Report: TAB Report
Function: Test, Adjust, & Balance
Date: 09/05/2025
Completed By: National TAB

PROJECT
08-25-25 WAWA #6613 CHANTILLY, VA

Project Issue Information

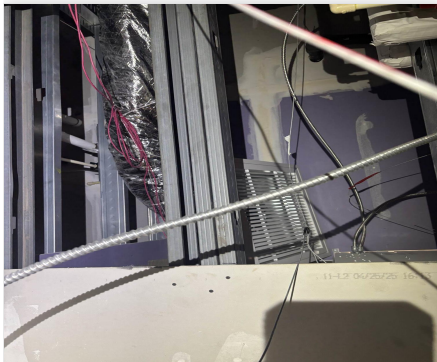
Issue Name : ALL RTU's MIXED AIR COMPARTMENT PLENUM PANEL INSULATION
Description : Insulation is coming loose from inside the mixed air compartment.
Recommend re-securing.
Created By : National TAB **Assigned To :** National TAB - Cody Mauro
Status : Open
Priority : High **Asset Tag :**
Originated Date : 08/27/2025 - Cody Mauro - National TAB

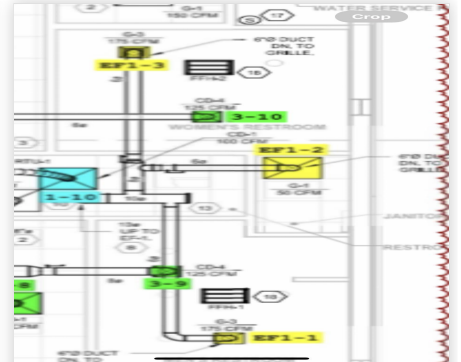
Issue Name : EF1-2 DIFFUSER
Description : Ef1-2 diffuser is sitting above the ceiling, not installed. Unable to measure airflow
Created By : National TAB **Assigned To :** National TAB - Cody Mauro
Status : Open
Priority : High **Asset Tag :**
Originated Date : 08/28/2025 - Cody Mauro - National TAB

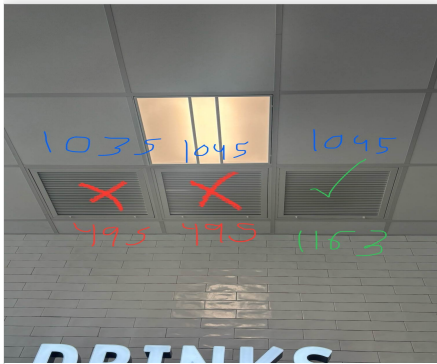
Issue Name : EF2 AIRFLOW LOW
Description : Airflow measured as 869 CFM out of design of 1400 CFM. Design static pressure is 0.25" but the actual static pressure is 0.56" which indicates restriction. Need the mechanical contractor to verify that the balancing dampers are fully open and not closed.
Created By : National TAB **Assigned To :** National TAB - Cody Mauro
Status : Open
Priority : High **Asset Tag :** EF2
Originated Date : 08/28/2025 - Cody Mauro - National TAB

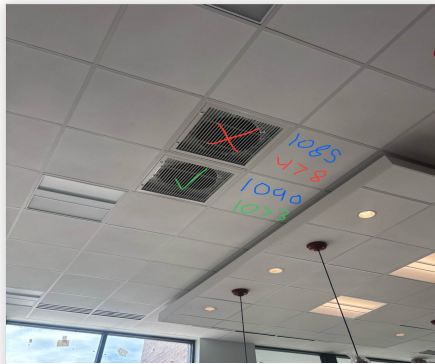
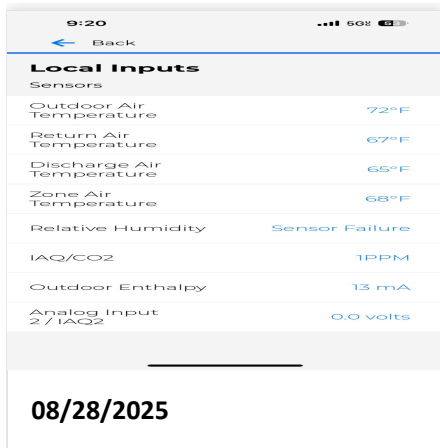
Issue Name : RTU 1 & 3 RETURN DAMPERS
Description : RTU 1 & 3 appear to have closed return dampers. There is elevated static pressure at the units as a result. Need assistance from the mechanical contractor to open the dampers due to the height of the ceiling.
Created By : National TAB **Assigned To :** National TAB - Cody Mauro
Status : Open
Priority : High **Asset Tag :**
Originated Date : 08/28/2025 - Cody Mauro - National TAB

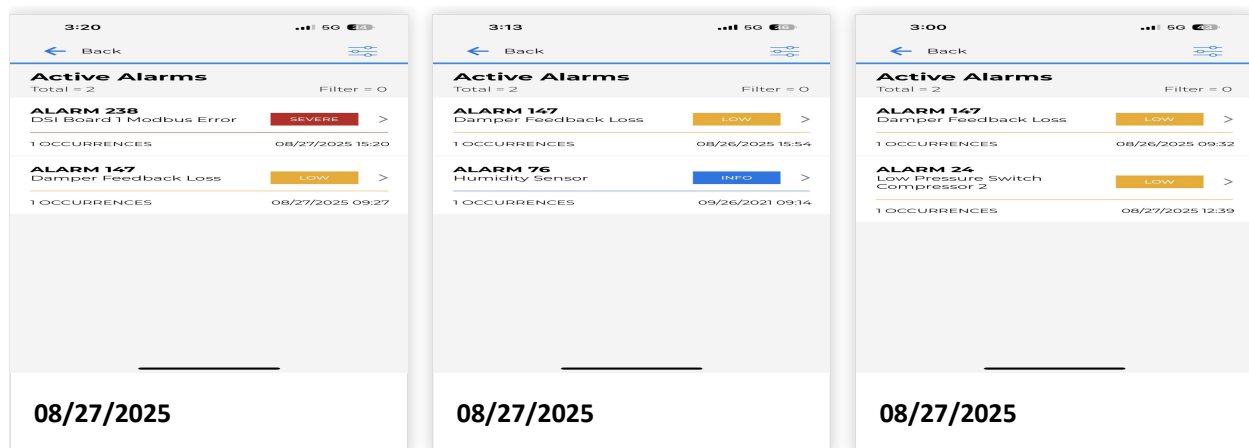
Cannot open panel without insulation getting sucked off. Needs to be resealed

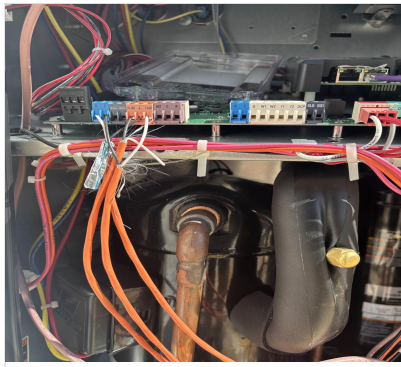
Verify that the CORE or Prodigy controller is sensing a relative humidity (record the reading) Fail

RTU1: 62% RTU2: Sensor Failure RTU3: 55%

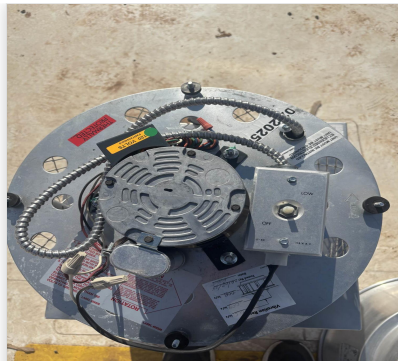
No backdraft damper installed for EF2

Speed controllers for both EF's are maxed, total not within +/-5%. Grilles unable to be balanced due to lack of air.
